ORIGINATION FORM

Proposed Revisions to a Standard Plans Index
(Please provide all information – Incomplete forms will be returned)

Index Number: **649-010**
Sheet Number (s): 1
Index Title: Steel Strain Pole

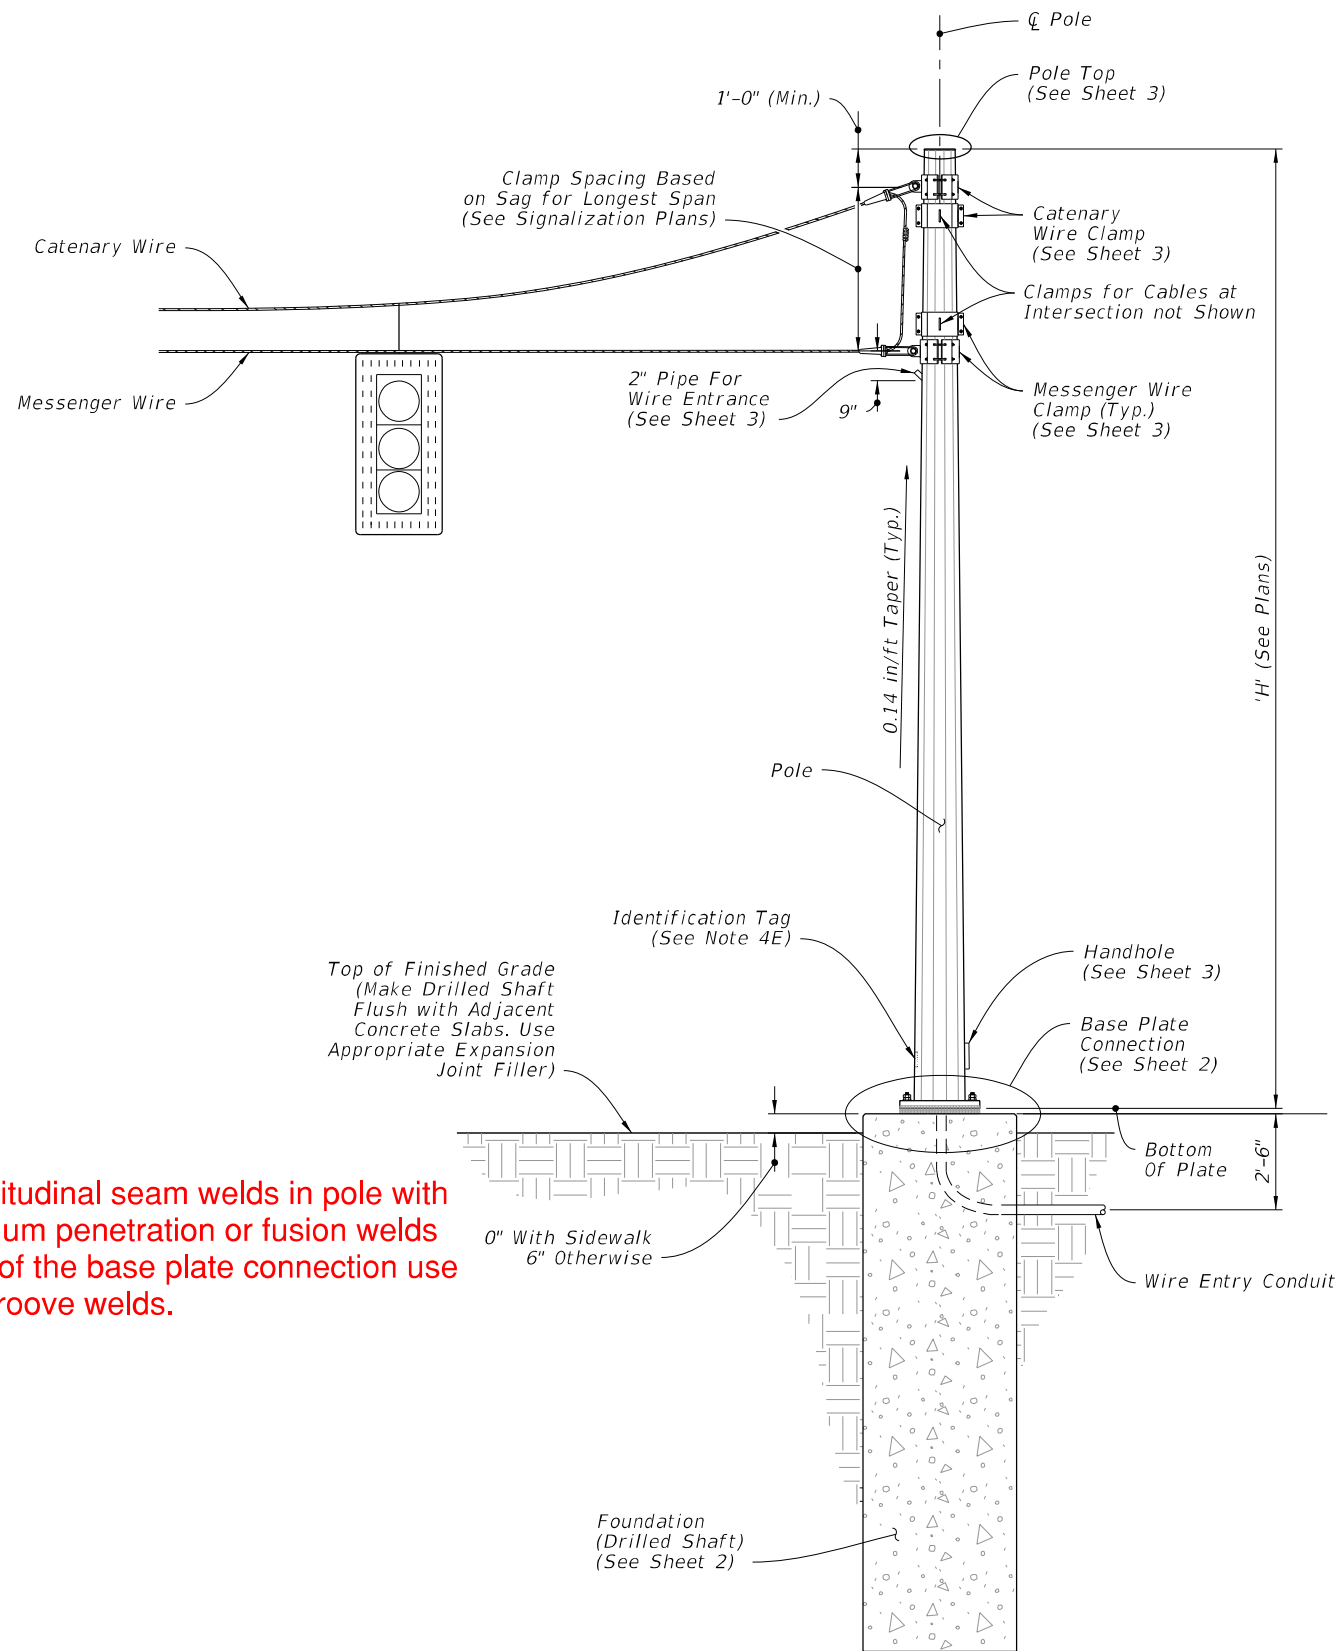
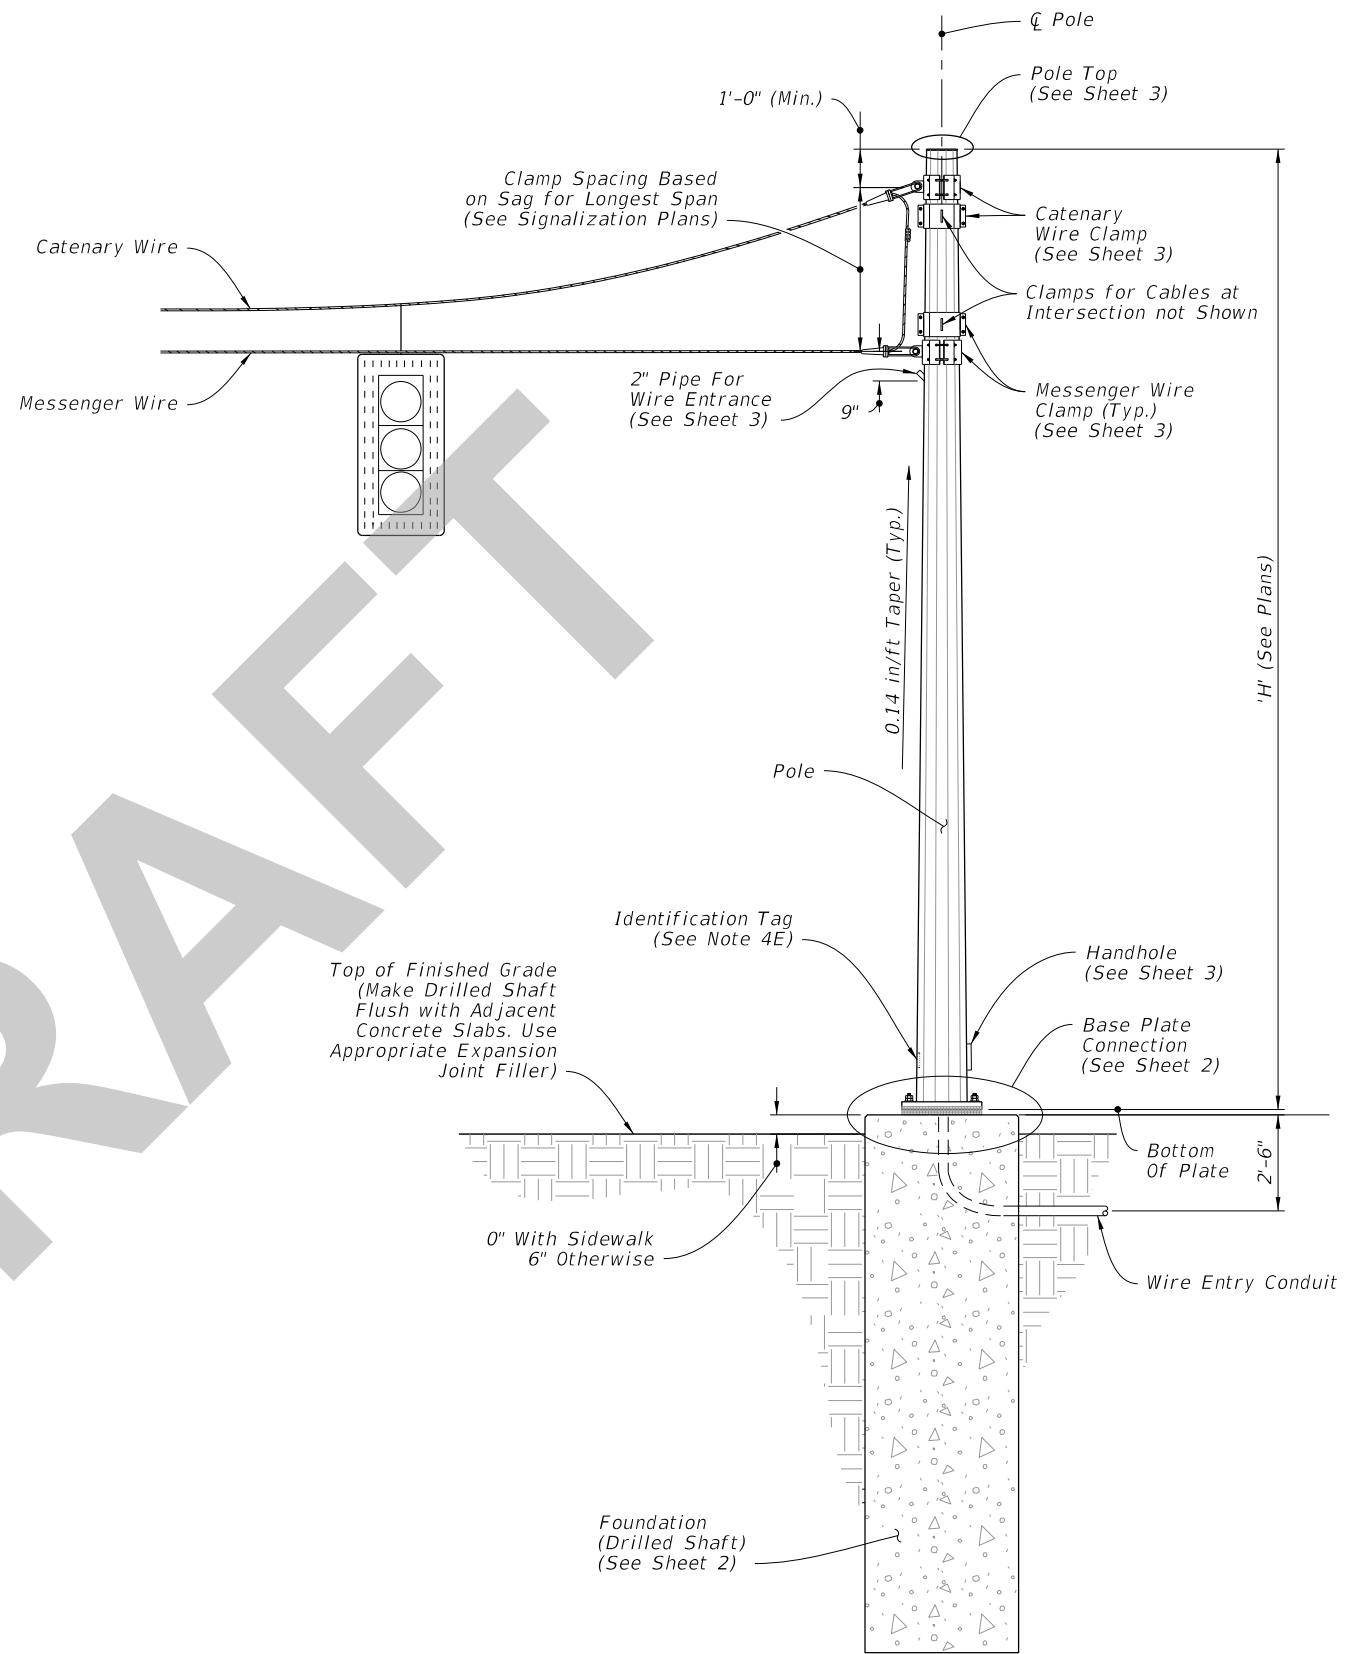
Added Note 4H (longitudinal seam weld); Changed note # 4H to 4I.

Longitudinal weld note added, same criteria as Mast Arms and High Mast Light Poles.

H. Fabricate longitudinal seam welds in pole with 60 percent minimum penetration or fusion welds except, within 6" of the base plate connection use full-penetration groove welds.

- G. Perform all welding in accordance with Specification 460-6.4.
- H. Fabricate longitudinal seam welds in pole with 60 percent minimum penetration or fusion welds except, within 6" of the base plate connection use full-penetration groove welds.

- I. Hot Dip Galvanize after fabrication.
